PRLIMINARY DRAINAGE REPORT

FIRST WING SUBDIVISION, FILING NO. 2
0 SPACE VILLAGE AVENUE
COLORADO SPRINGS, COLORADO

Please add "PCD File No. MS-22-007".

MAY 5, 2022

OS-E Diversion Channel

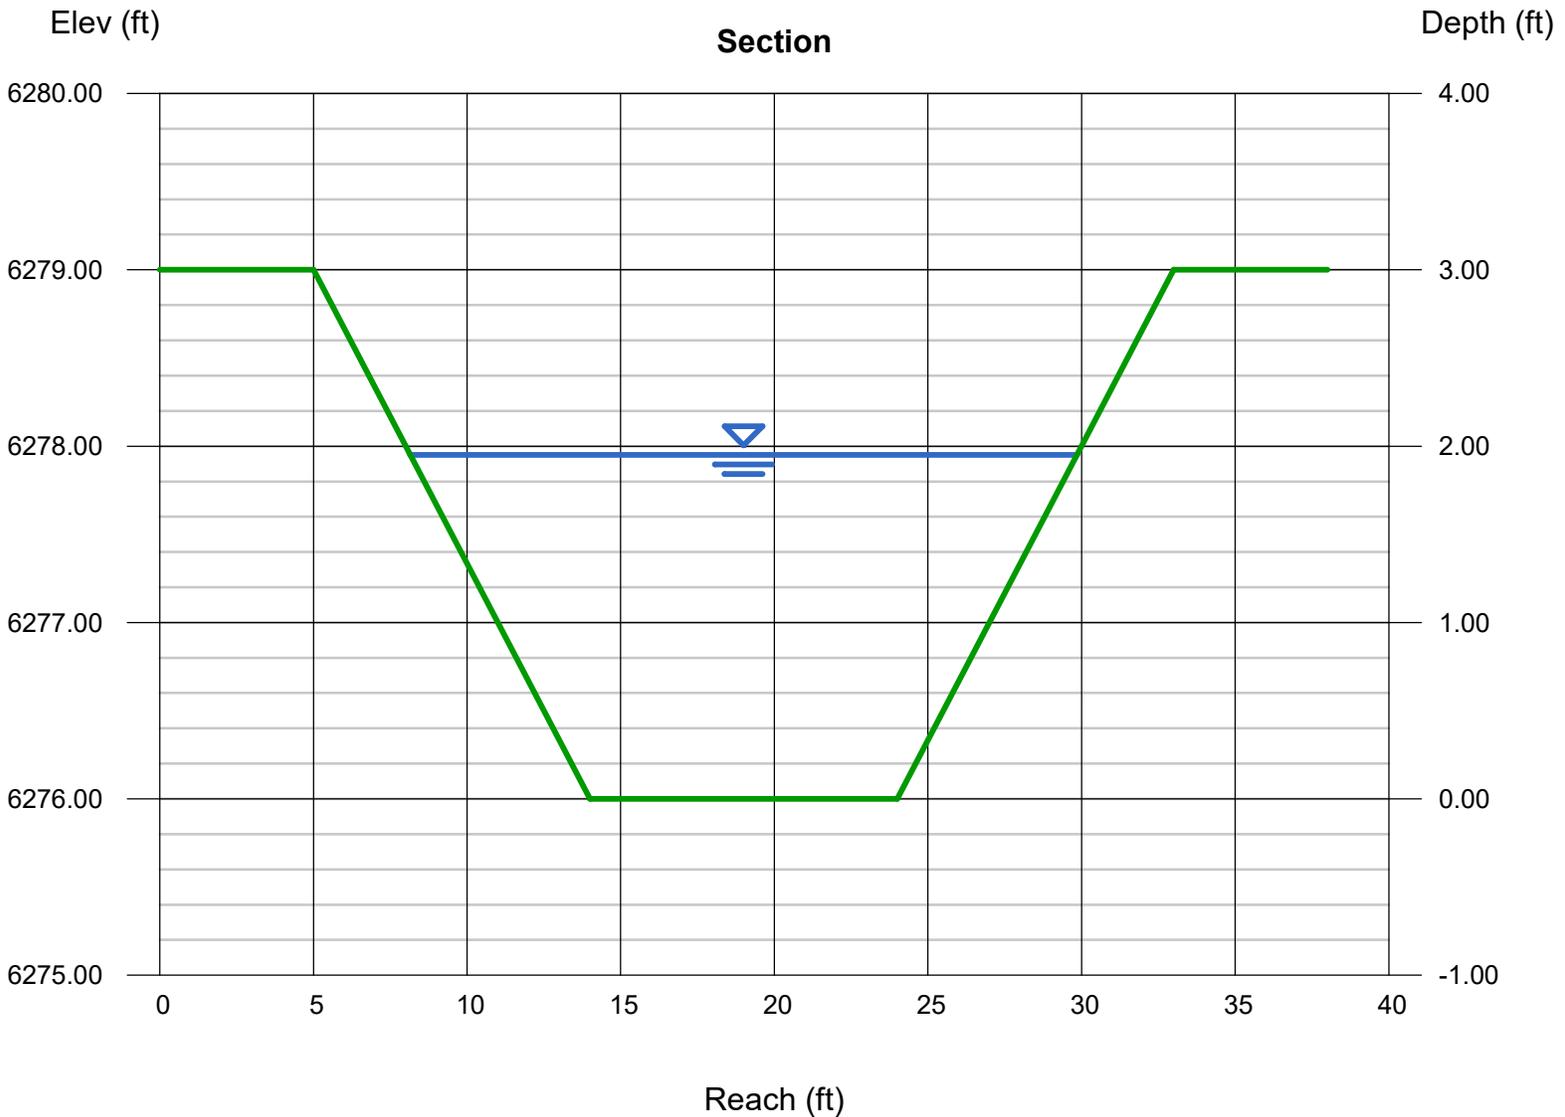
Please identify what is required/proposed for the swale/channel.

0 SPACE VILLAGE AVENUE
 A PORTION OF THE NW 1/4 OF SEC. 17, T14S,
 R65W, OF THE 6th P.M., EL PASO COUNTY, COLORADO
 PRELIMINARY DRAINAGE PLAN
 EXISTING CONDITION & OFF-SITE

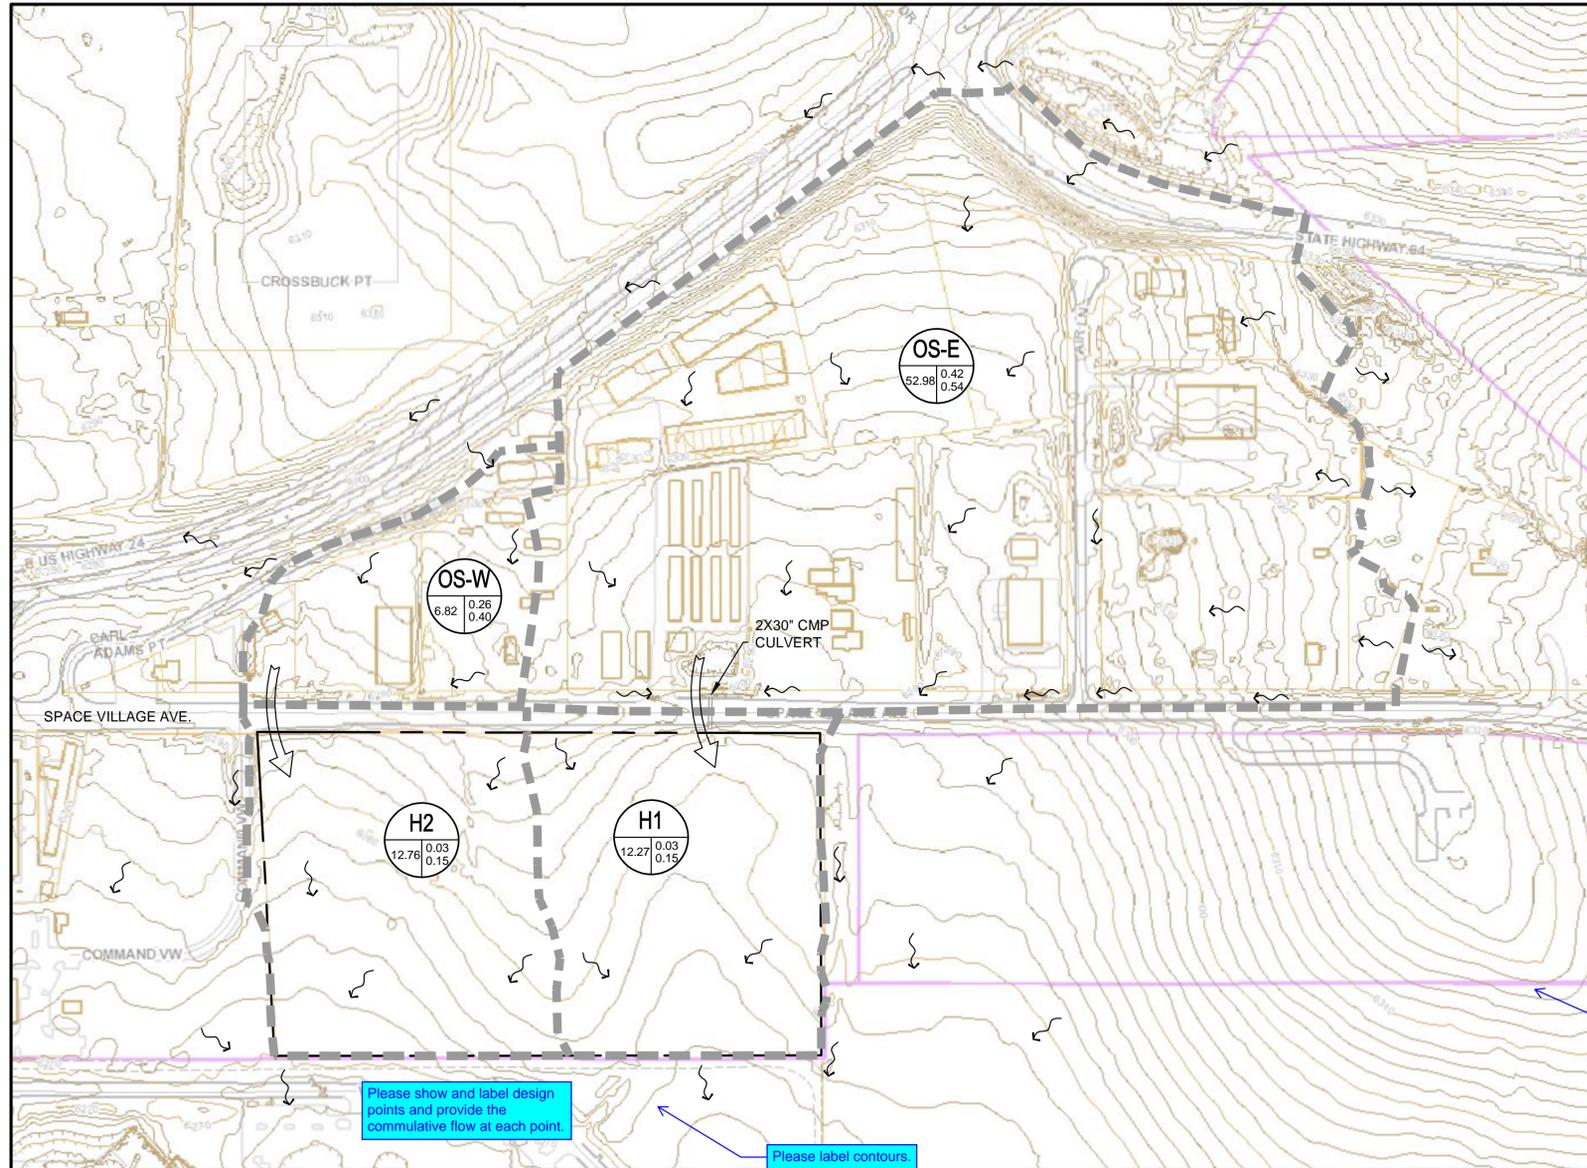
Please delineate the time of concentration paths for each basin on the drainage map.

0 SPACE VILLAGE AVENUE
 A PORTION OF THE NW 1/4 OF SEC. 17, T14S,
 R65W, OF THE 6th P.M., EL PASO COUNTY, COLORADO
 PRELIMINARY DRAINAGE PLAN
 PROPOSED CONDITION

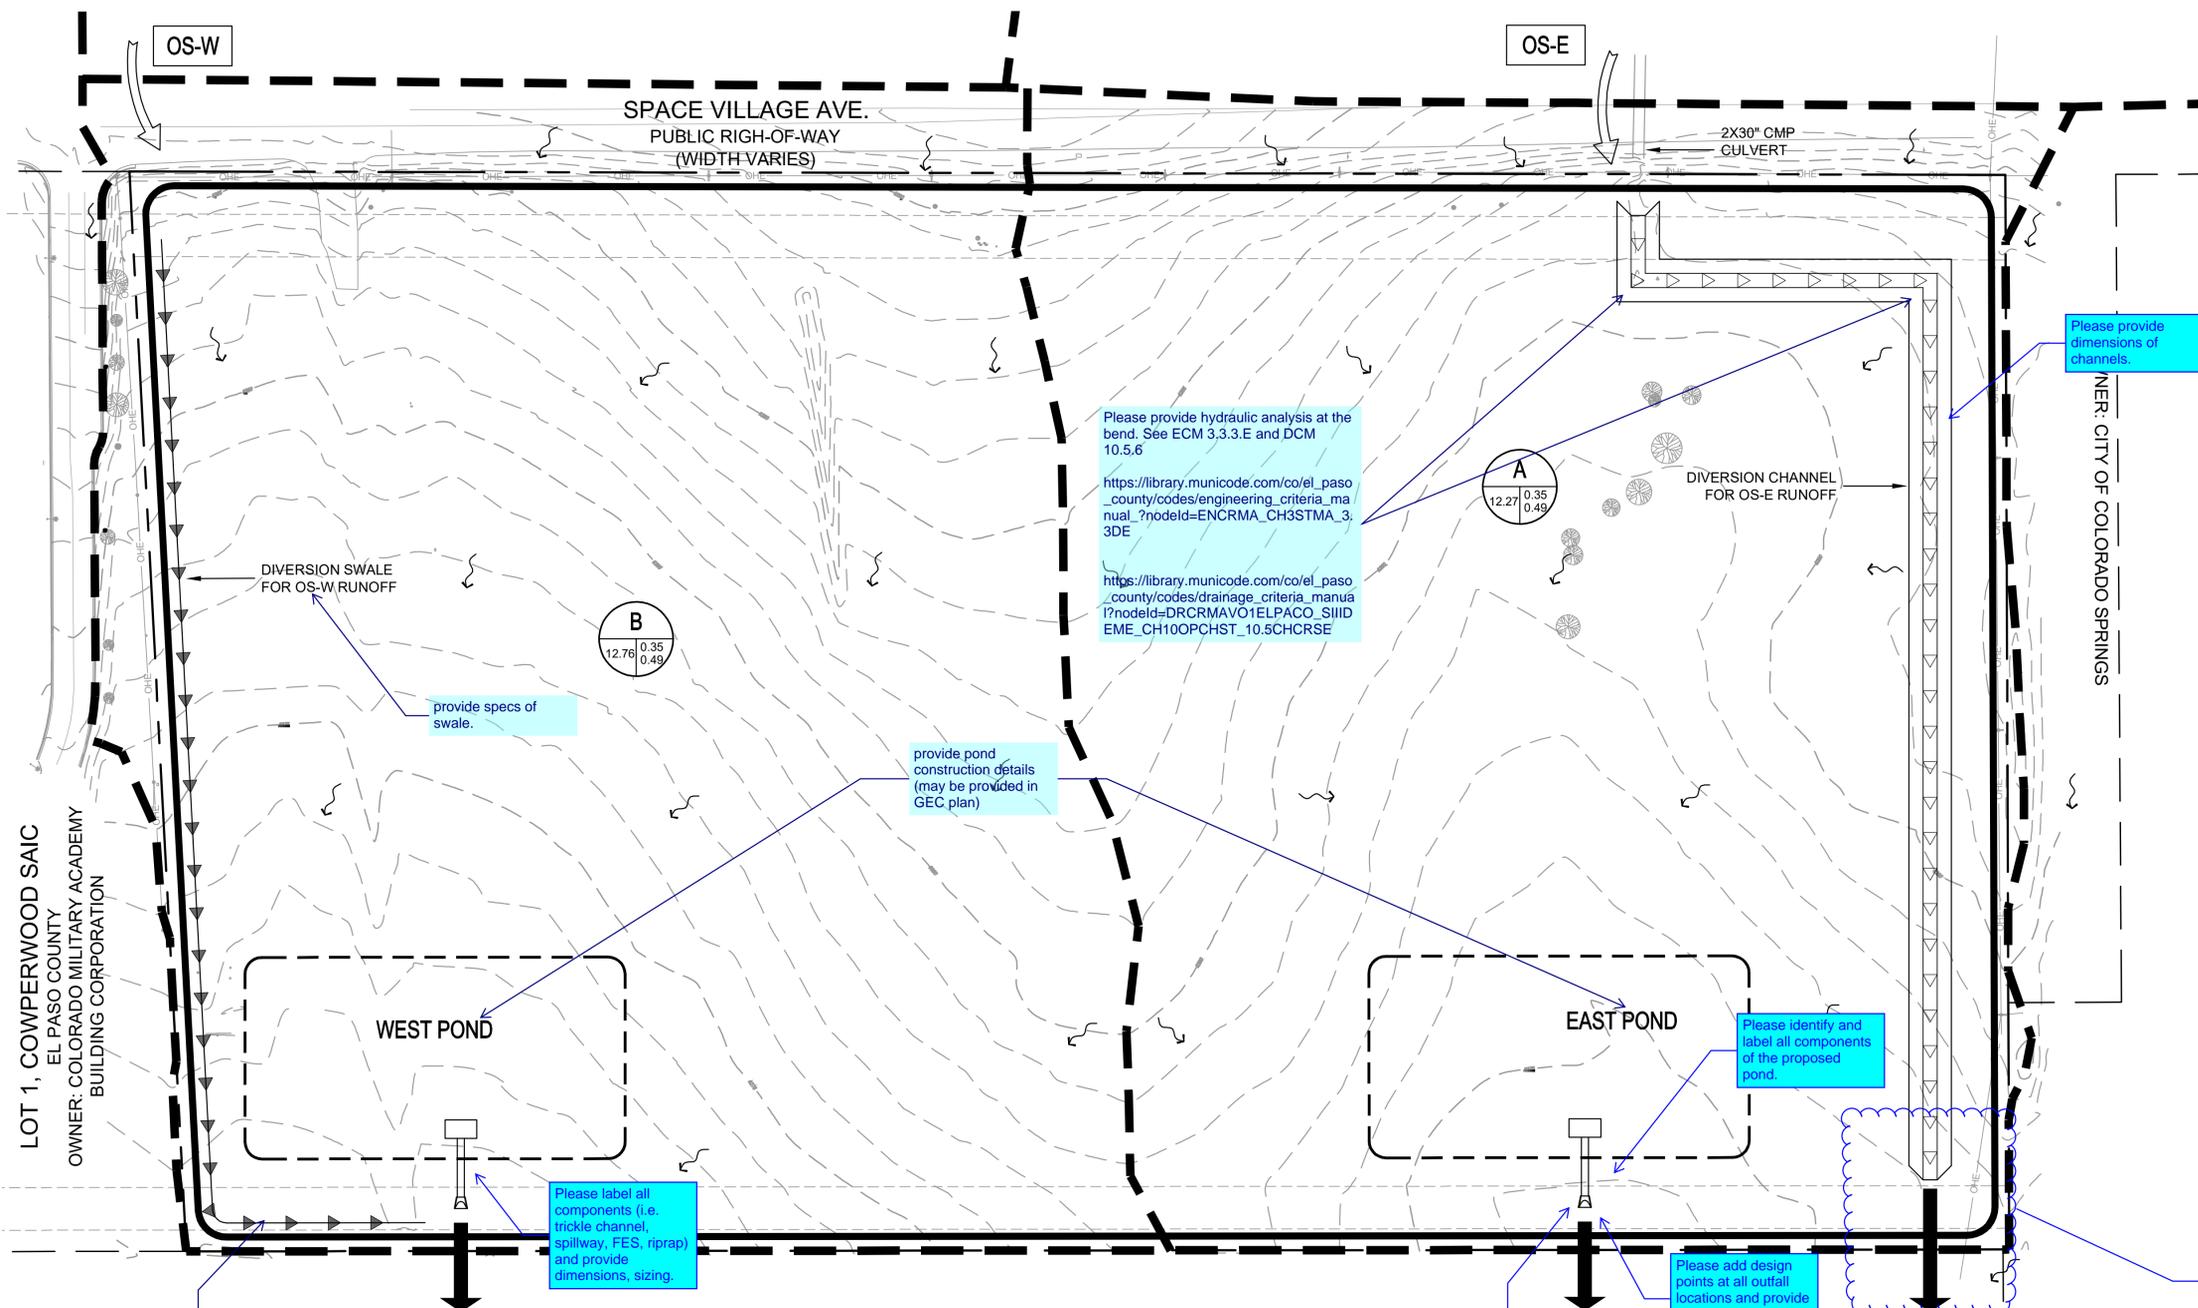
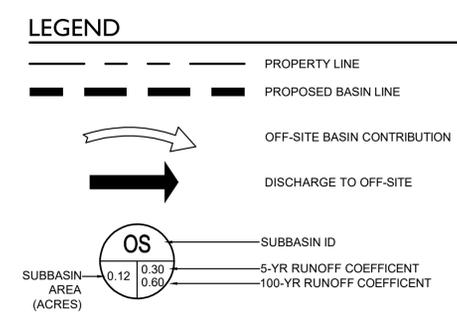
Please revise drainage maps as the Grading and Erosion Control Plan shows a different design and layout.

Please provide hydraulic analysis at the bend. See ECM 3.3.3.E and DCM 10.5.6
https://library.municode.com/co/el_paso_county/codes/engineering_criteria_manual/?nodeId=ENCRMA_CH3STMA_3_3DE
https://library.municode.com/co/el_paso_county/codes/drainage_criteria_manual/?nodeId=DRCRMAV01ELPACO_SIIID_EME_CH10OPCHST_10.5CHCRSE

Please label all components (i.e. trickle channel, spillway, FES, riprap) and provide dimensions, sizing.

Please add design points at all outfall locations and provide the cumulative flow rates.

Please identify in the report why the flow is being directed in this direction instead of towards the detention pond. The contours suggest historical runoff patterns flow towards the proposed pond.
 Additionally, the channel shown on the GEC plan is being directed to the pond. Please address/revise accordingly.

The GEC plan shows this swale leading to the pond. revise accordingly.

Please delineate the time of concentration paths for each basin.
